MINUTES
BOARD OF BUILDING STANDARDS/
ARCHITECTURAL BOARD OF REVIEW/SIGN REVIEW
REVIEW MEETING
CITY OF LAKEWOOD
12650 DETROIT AVENUE
AUDITORIUM
FEBRUARY 12, 2026
5:30 P.M.
MEETING RECORDED
<https://www.lakewoodoh.gov/videos-2/>

SUMMARY APPROVED

Docket No. 02-16-26 (1374 W. 117th)

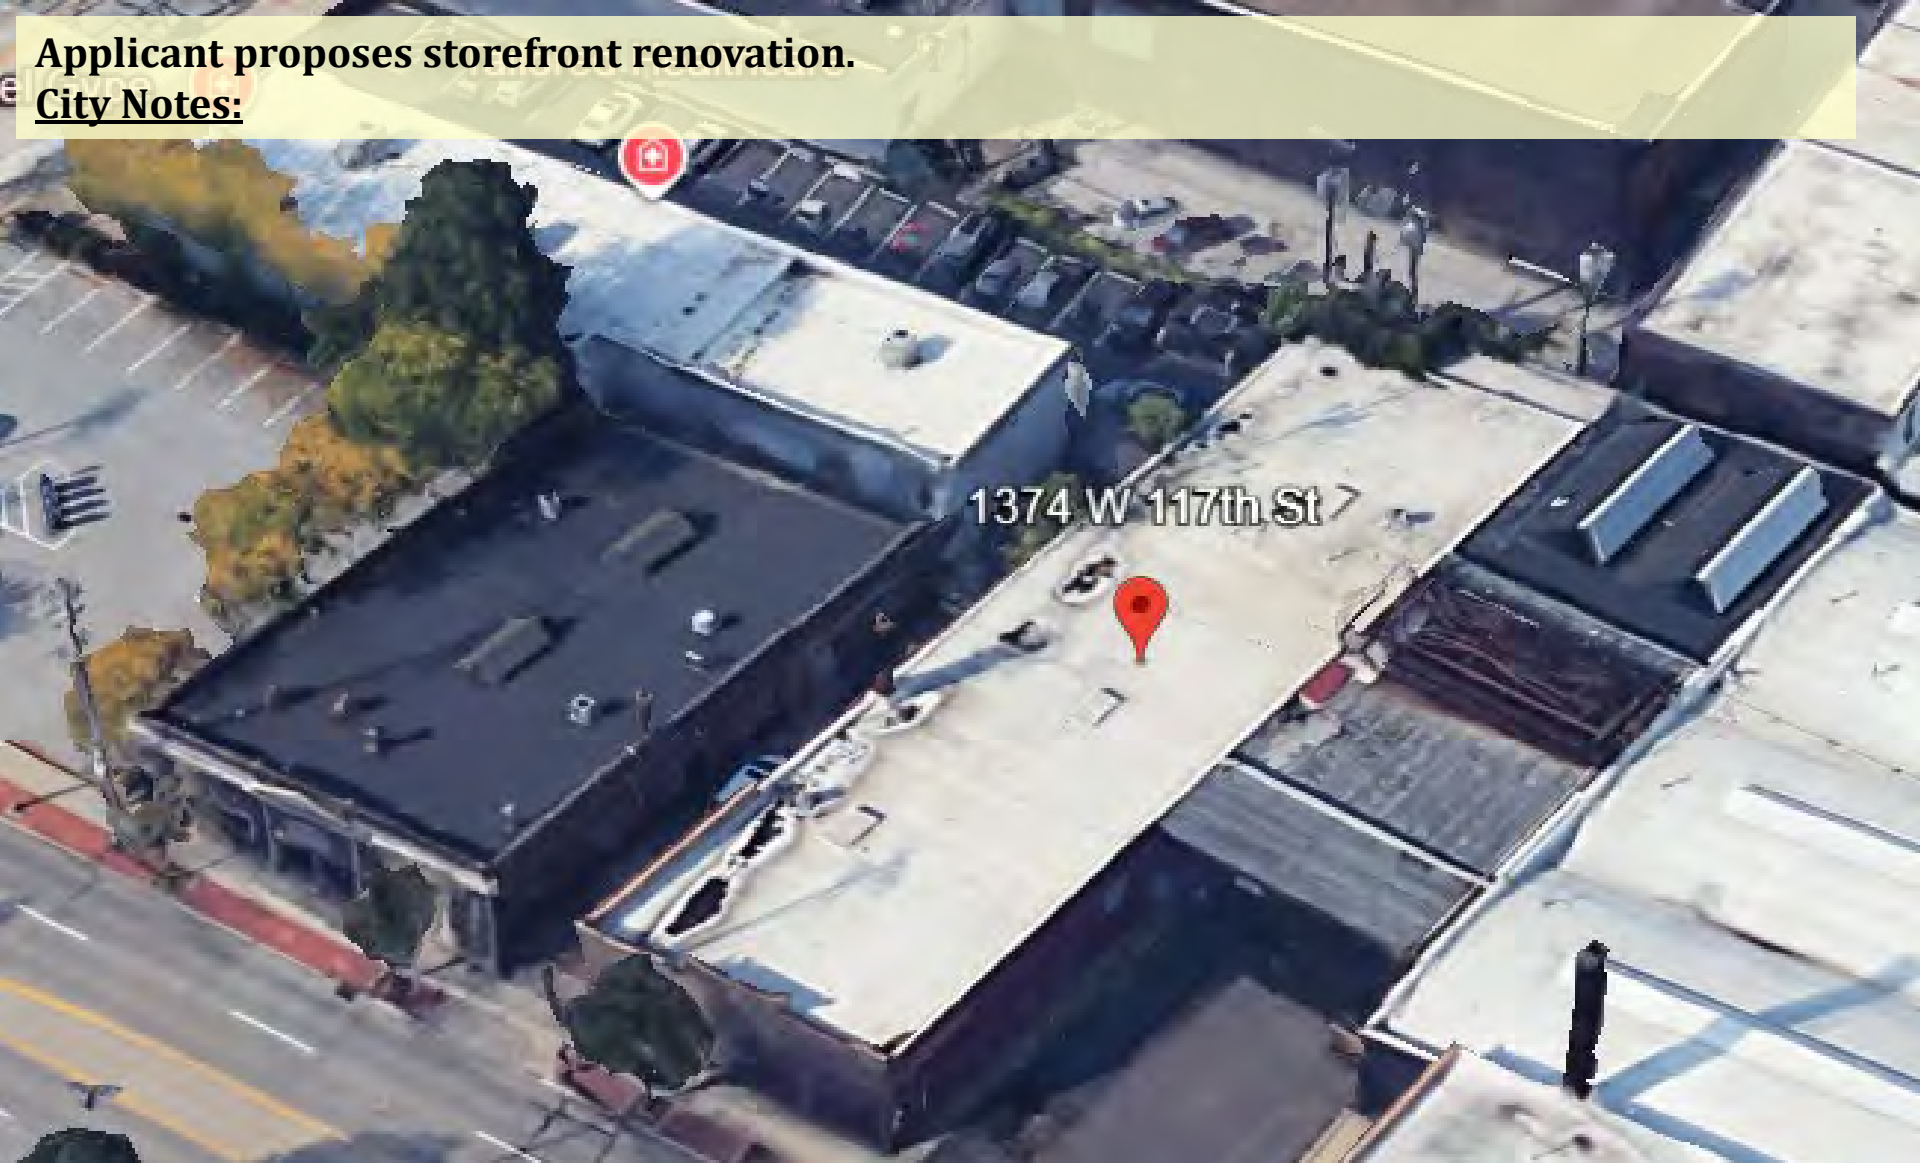
Jeff Foster, Payto Architects and Tricia Rhea, owner were both present. Discussion was made on opening up the storefront and keeping the door opaque. The Board felt the lap siding is an issue as it reads residential. If the garage door was removed, it would really open it up. There are three parcels and only one is office space. The back building is a warehouse that can only be accessed from the dock door. Discussion

on changing the dock door as there is no vehicular access to the back building. The idea of a recess door is a good idea. The Board was unsure of the color choice for the front façade. Applicant wants the building to look nicer but there are budget constraints. Two of the parcels will be sold at some point, leaving only the occupied office space belonging to Ms. Rhea. Mr. Foster provided additional information/details that was asked for. Additional discussion on the left bay being spandrel and that it would go a long way or could the left side just be solid. Mr. Foster also mentioned that there were no windows and that they are proposing vision glass.

A motion was made by Ms. Plessner, Chair, seconded by Mr. Slaughterbeck to DEFER Docket No. 02-16-26. All the members voted yea; the motion passed.
